LOCATION: Land between Sweets Way and Oakleigh Road North, London, N20
REFERENCE: B/02710/13 **Received:** 28 June 2013
Accepted: 02 July 2013
WARD: Totteridge **Expiry:** 01 October 2013

PROPOSAL: Demolition of all existing buildings and outline planning permission (with all matters other than access reserved) for new residential dwellings (Use Class C3), comprising up to 189 houses and up to 171 flats (up to 360 new dwellings in total), and a community building (Use Class D1) providing up to 292m² of floorspace. The provision of site access from Sweets Way and Oakleigh Road North.

RECOMMENDATION

APPENDIX 2: PROPOSED SITE LAYOUT PLAN

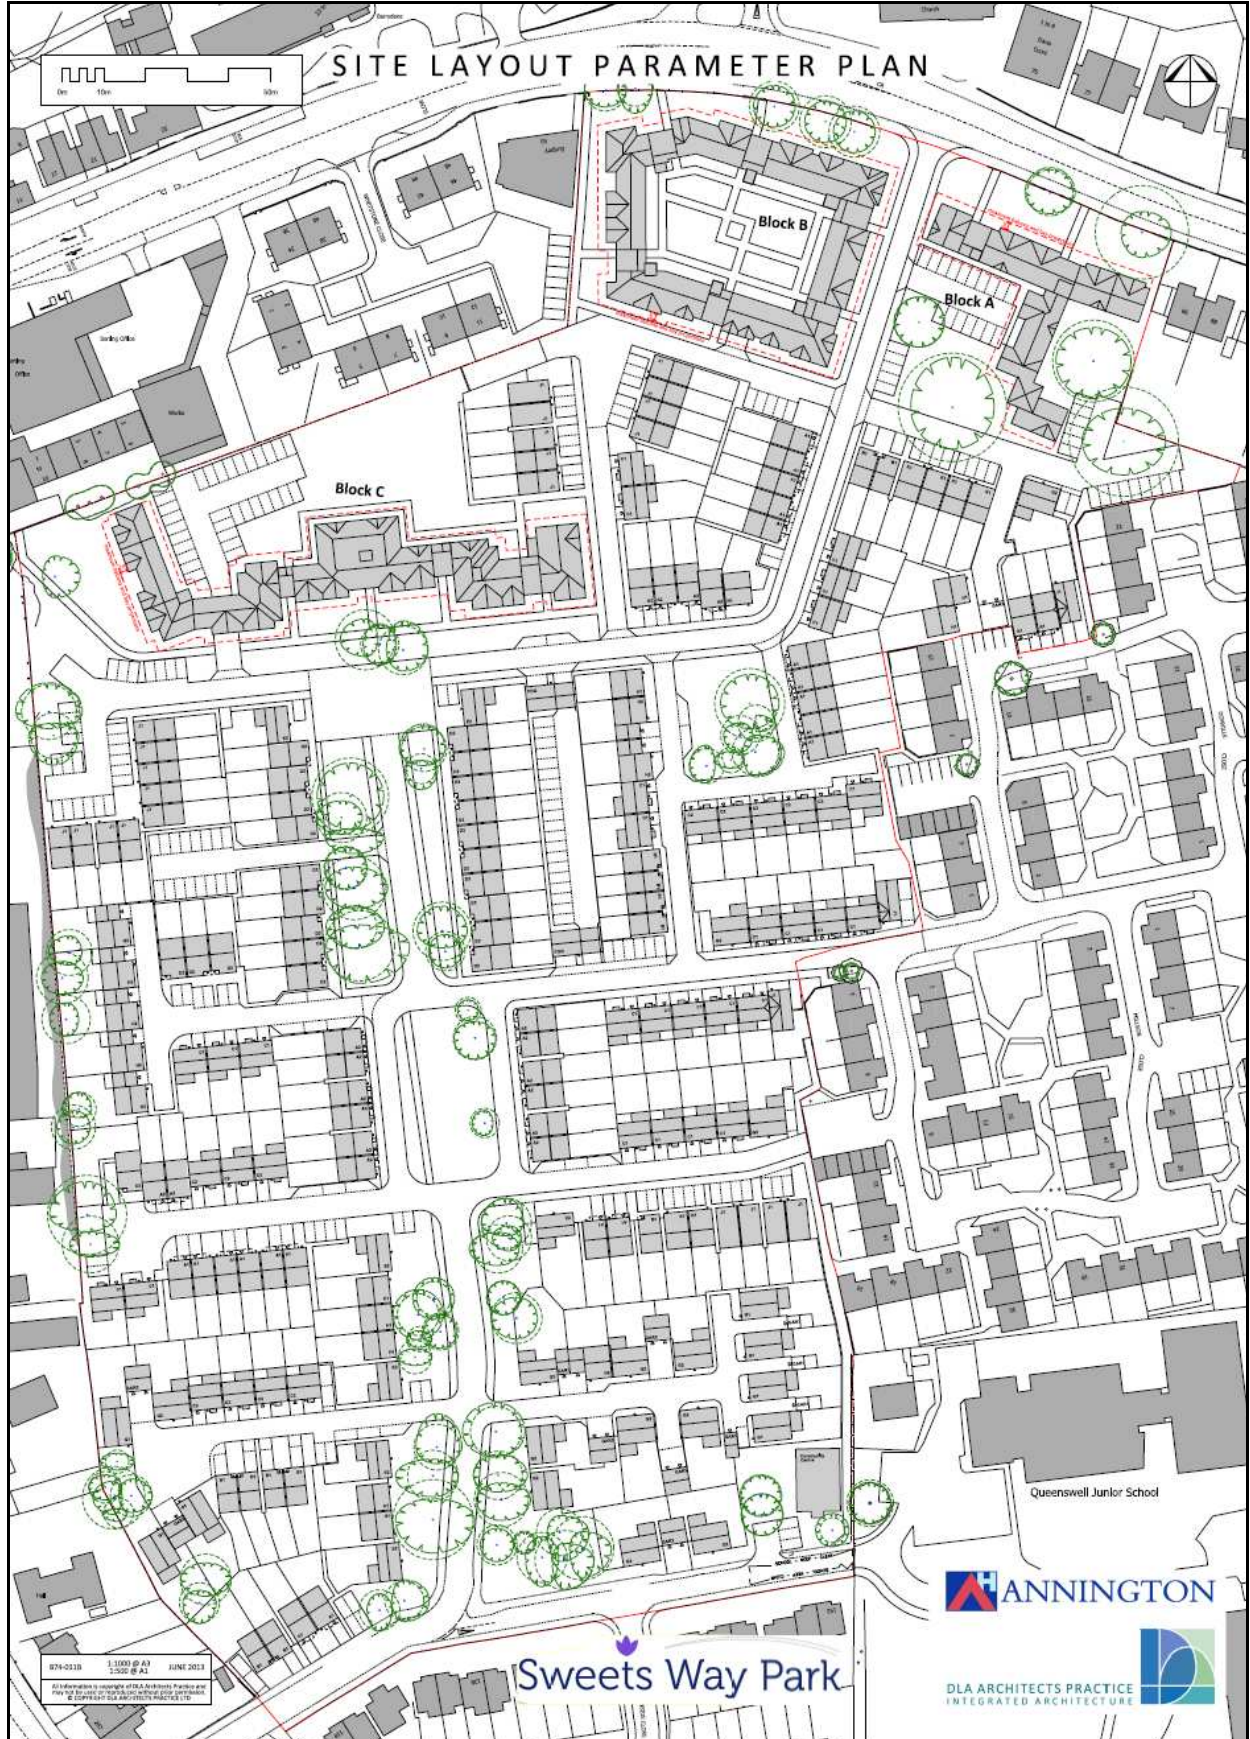
1. The proposal would, by reason of its design and the parameters sought for approval, represent a cramped form of development that would create unacceptable levels of overlooking and provide insufficient privacy for the future occupiers of a number of the houses proposed on the site, both from other proposed houses and from existing neighbouring houses at 12 and 14 Domville Close, to such an extent that it would be detrimental to their residential amenities. The proposal would therefore not constitute a sustainable form of development which optimises the housing potential of the site and be contrary to policies DM01, CS NPPF and CS5 of the Barnet Local Plan Core Strategy and Development Management Policies Document (both adopted September 2012), policies 3.4 and 3.5 and 7.6 of the London Plan (adopted July 2011 and October 2013) and the guidance contained in the Barnet Residential Design Guidance Supplementary Planning Document (adopted April 2013).

2. The proposal would, by reason of its design and the parameters sought for approval, represent a cramped form of development that would fail to provide the future occupiers of a number of the houses proposed with adequate levels of individual external amenity space to the detriment of their residential amenities. The proposal would therefore not constitute a sustainable form of development which optimises the housing potential of the site and be contrary to policies DM01, DM02,

3. The proposal would, by reason of its design and the parameters sought for approval, constitute a cramped form of development that would result in the occupiers of existing dwellings at 12 and 14 Domville Close suffering unacceptable levels of overlooking from a number of the proposed houses, to such an extent that it would cause them to suffer a loss of privacy and be detrimental to their residential amenities. The application would therefore not constitute a sustainable form of development which optimises the housing potential of the site and be contrary to policies DM01, CS NPPF and CS5 of the Barnet Local Plan Core Strategy and Development Management Policies Document (both adopted September 2012), policies 3.4 and 3.5 and 7.6 of the London Plan (adopted July 2011 and October 2013) and the guidance contained in the Barnet Residential Design Guidance Supplementary Planning Document (adopted April 2013).
